## Amended Plans Submission Form (Application Not Approved)

8-14 Sherbrook Road and 78-82 Mons Avenue, West Ryde Local Development Application No. LDA2014/0419

**REVISED SCHEME**

This report has been prepared in response to issues raised by Council in its assessment of the subject development application (DA No LDA2014/0419). It integrates the various responses to the items set out in Council's letter of 16 February 2015 (Appendix A), as well as subsequent Council comments on draft amended plans.

Drawing No 24

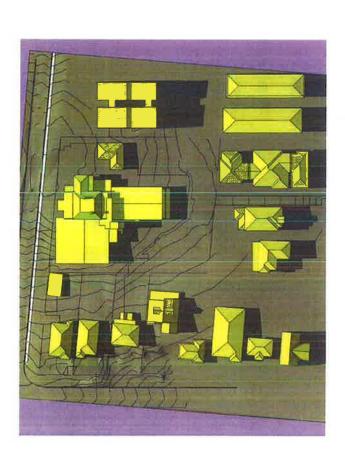
3.	SEPP Clause 33 - Amenity	See 4.0
4.	SEPP Clause 40 - Height	See Drawing No 24
5.	SEPP Clause 48-Landscaping calculations	See Landscape Drawing L-SD- 06 and revised statistics

Existing + New Figure Ground

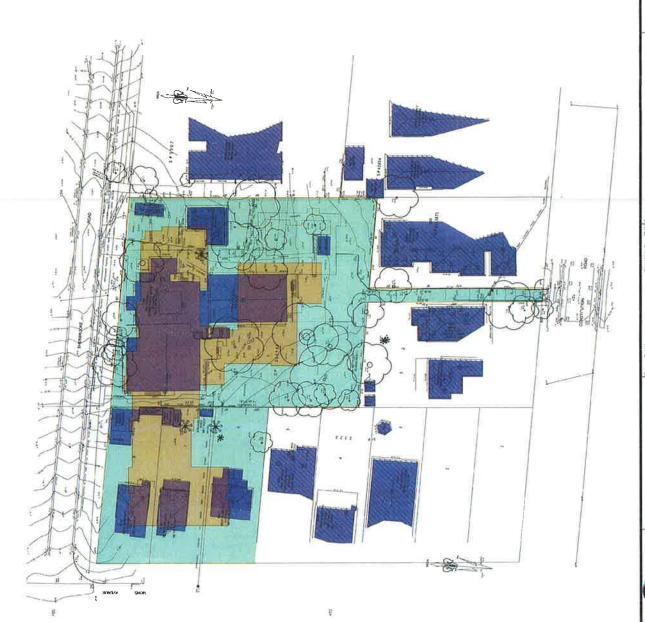
The particular issue of the length of the building elevation to Sherbrooke Road was addressed in the original site analysis and design assessment, in terms of the balancing of site and contextual factors that acted to push building mass towards the Sherbrooke Road frontage, and the subsequent design attention to reducing building height (in turn related to operating requirements and site topography), and measures to articulate the façade. The set-back to Sherbrooke Road has been based on existing set-back patterns (Refer drawing 31).
